LAND NORTH OF MILL LANE, SINDLESHAM

HIGHWAYS RESPONSE NOTE

REPORT REF.
2506120_B-ACE-XX-00-RP-C-0101

Date: 30 October 2025
Application: 252601

Figure 2.1: Existing Refuse Collection Vehicle

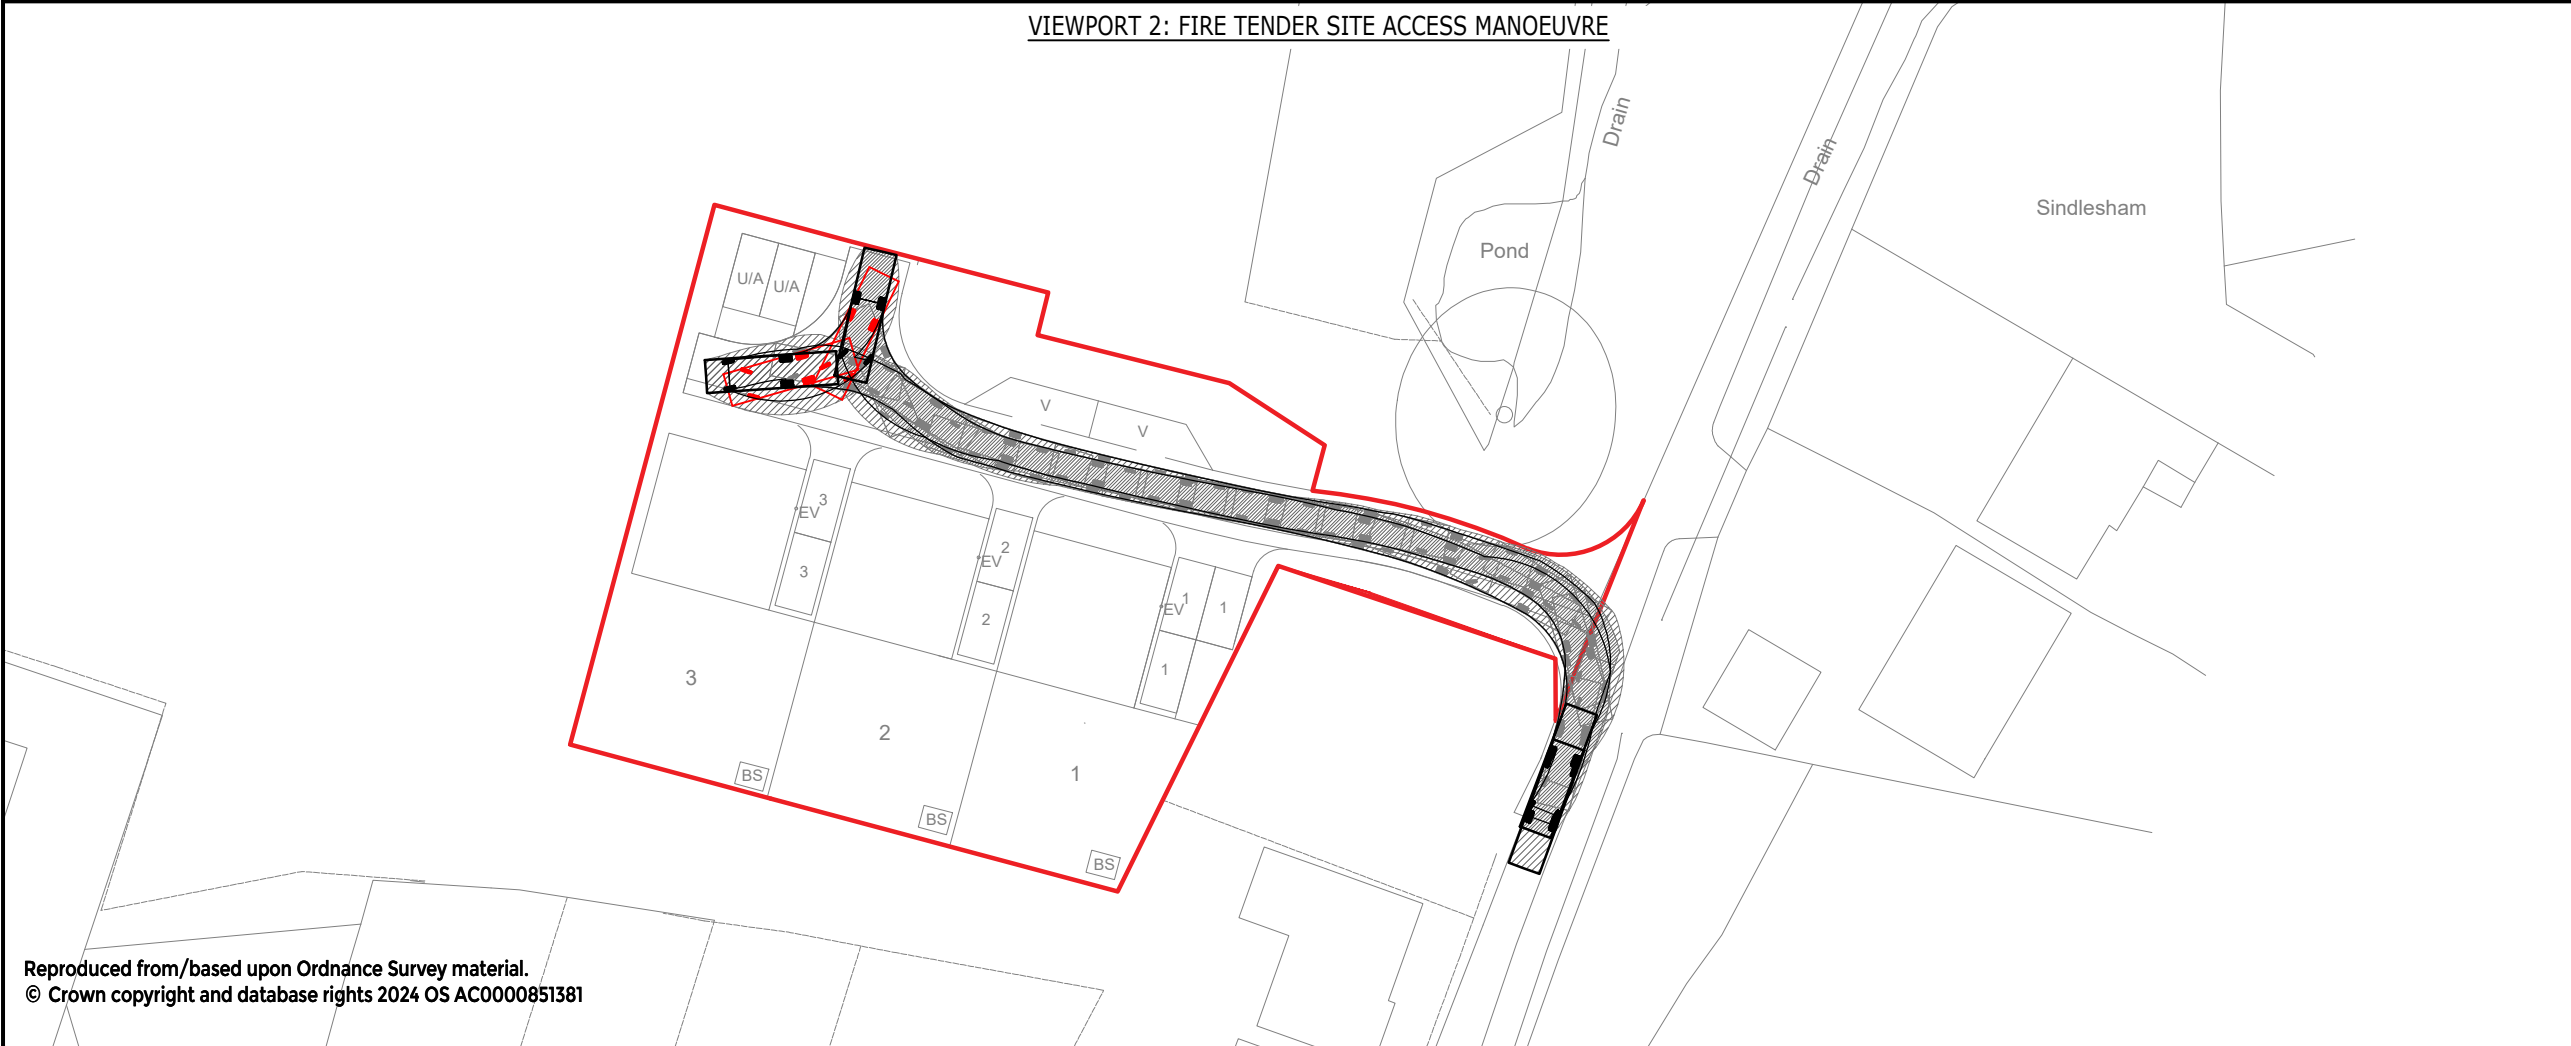
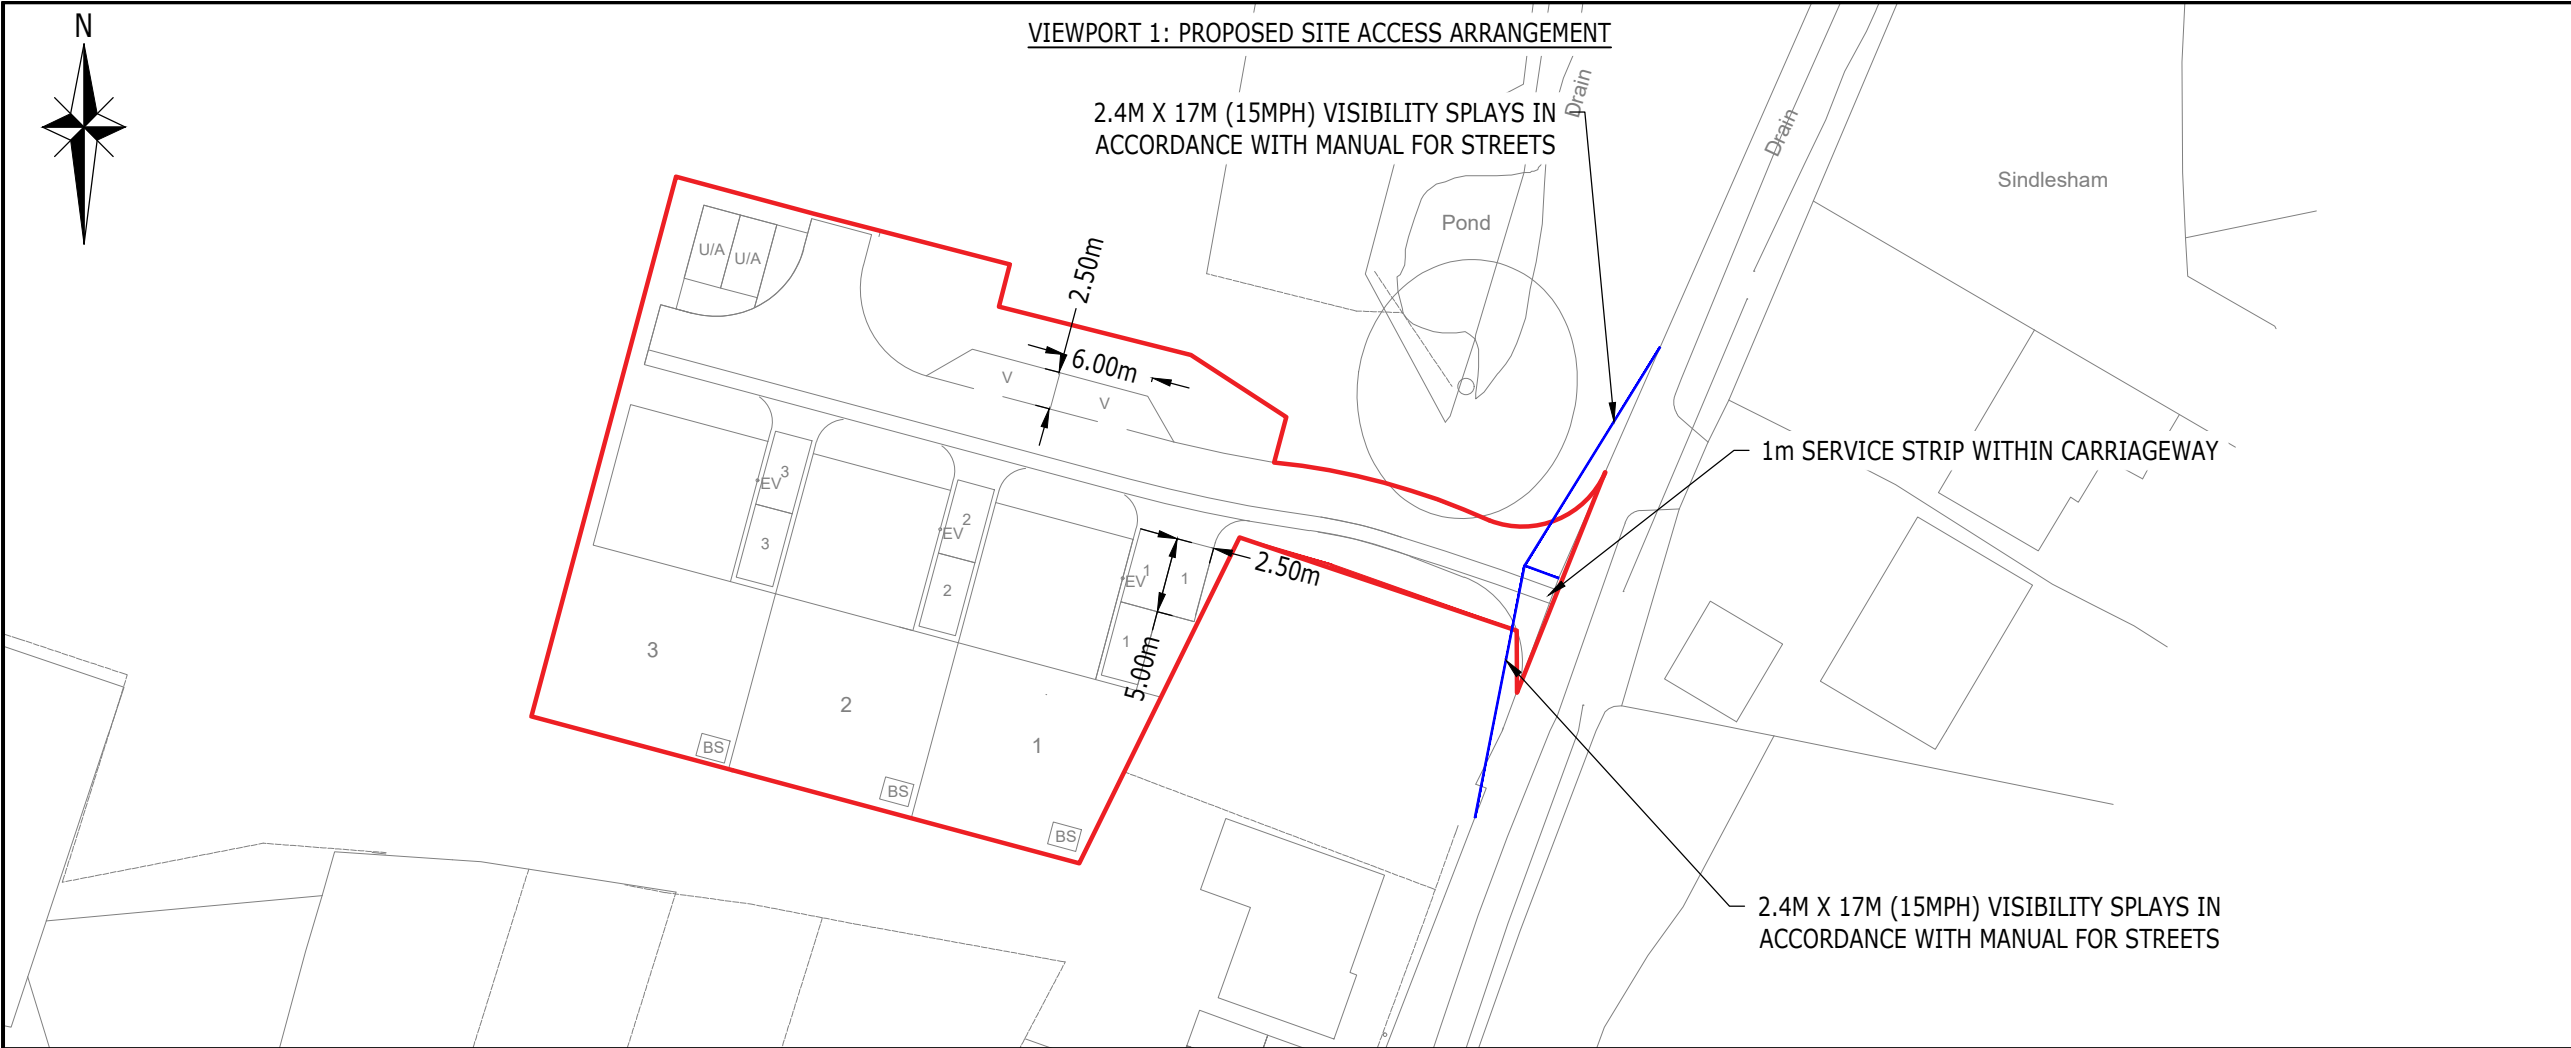
"As the proposed development will be accessed through the existing access of private road, the applicant shall clarify how refuse collection servicing is going to be provided. Though highways have assumed that this will be the existing collection will be retained.

If council refuse collection will be applicable for this site, the applicant will need to provide the swept path for refuse vehicles entering and leaving the site in forward gear with the following standards:"

- 2.19. Review of the existing refuse collection arrangement for the surrounding dwellings outlines that a full-size collection vehicle does not serve the private road. **Figure 2.1** below shows a photograph of refuse collection for the existing dwellings utilising a smaller refuse vehicle.

2.20. It is anticipated therefore that the same refuse collection strategy would be utilised for the proposed dwellings, where an on-site bin store would ensure that the maximum carrying distance for residents (30m) and refuse collection operators (25m) is met.

SITE ADDRESS	-	Land North of Mill Lane, Sindlesham Wokingham, RG41 4DF
DRAWING TITLE	-	Bike Store, plans and Elevations
DRAWING REF	-	PL-11
DRAWING SCALE	-	1:50@A4
DRAWING REV	-	P1

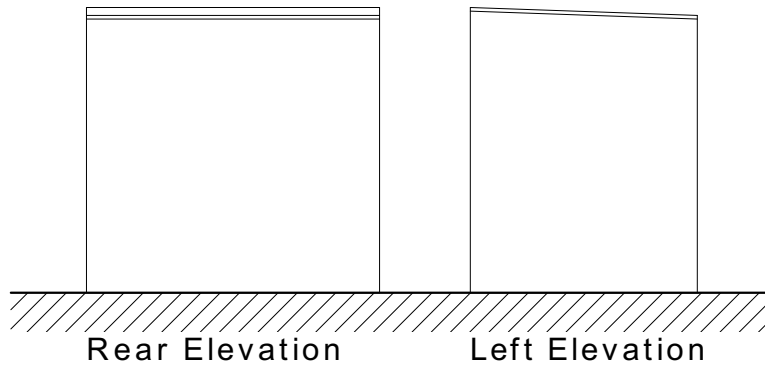
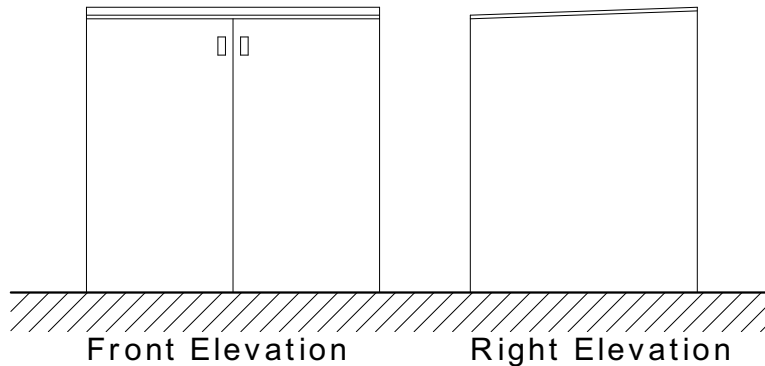
A cycle store has been indicated at the rear garden, which is acceptable. However, the proposed cycle store of internal dimensions of 2.1m x 0.81m will not be sufficient to store three bikes. Revision is required."

A cycle store has been indicated at the rear garden, which is acceptable. However, the proposed cycle store of internal dimensions of 2.1m x 0.81m will not be sufficient to store three bikes. Revision is required.

A cycle store plan (**Appendix C**) has been revised to show cycle stores with internal dimensions comprising 1.4m x 1.8m, which is suitable for the storage of 3 bikes for each dwelling, as shown within the cycle store plan.
